Access Compliance Report Public Rights-of-Way (Curb Ramps)

Main Street: N/A		Cross Street: BALL_RD		Location:	NE
ADA ID: RPAT211129094815	Ramp Type:Type 1 - Perpendicular	Initial Pass/Fail: Fail	Overall Compliance: No	Severity Score:	15

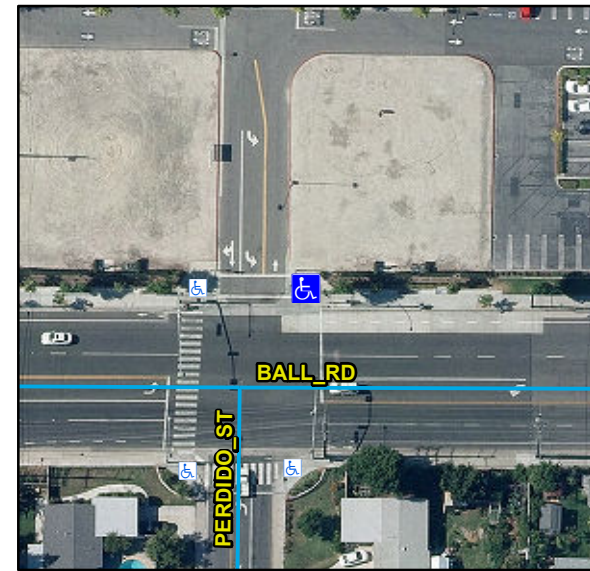
Compliance	Description	Data	Compliance	Description	Data
N/A	Ramp Length (in)	109	N/A	Flare Type LT	
Yes	Ramp Width (in)	48			N/A
No	Ramp Run Slope (%)	9.5	N/A	Flare Slope LT (%)	N/A
Yes	Ramp Cross Slope (%)	1.2	N/A	Flare Traversable LT	N/A
N/A	Landing Present	N/A	N/A	Flare Type RT	
N/A	Landing Length (in)	N/A			N/A
N/A	Landing Width (in)	N/A	N/A	Flare Slope RT (%)	N/A
N/A	Landing Run Slope (%)	N/A	N/A	Flare Traversable RT	N/A
N/A	Landing Cross Slope (%)	N/A	N/A	DWS Provided	N/A
N/A	Landing Movement Obstructed?	N/A	N/A	DWS Contrast	N/A
	Landing Movement Type	N/A	N/A	DWS Length (in)	N/A
N/A	Landing Shared	N/A	N/A	DWS Full Width	N/A
N/A	Clear Space	N/A	N/A	DWS Offset Left (in)	N/A
N/A	Clear Space To Crosswalk (in)	N/A	N/A	DWS Offset Right (in)	N/A
N/A	Marked Crosswalk 1	Yes	N/A	Marked Crosswalk 2	N/A
	Crossing 1 Direction	W		Crossing 2 Direction	N/A
	Marked Crosswalk 1 Width (in)	120		Marked Crosswalk 2 Width (in)	N/A

N/A	Ramp Inside Crosswalk 1	Yes	Yes	Ramp Inside Crosswalk 2	N/A
	Crossing 1 Slope (%)	3.7		Crossing 2 Slope (%)	N/A
	Crossing 1 Cross Slope (%)	4.3		Crossing 2 Cross Slope (%)	N/A
N/A	Gutter Ponding	N/A	No	Curb Slope	7.6
Yes	Gutter Lip Height (in)	0		Road Run Slope (%)	N/A
N/A	Gutter Run Slope (%)	N/A		Road Cross Slope (%)	N/A
N/A	Gutter Cross Slope (%)	N/A			
Yes	Overall Surface Condition: Acceptable		Yes	Perp Joint Present	Yes
	Cross Gutter Present?	Yes		Spandrel Present?	Yes
	Replace Cross Gutter?	No		Replace Spandrel?	No

Remove & Replace Entire Ramp.

R304.2.2, STD 1115
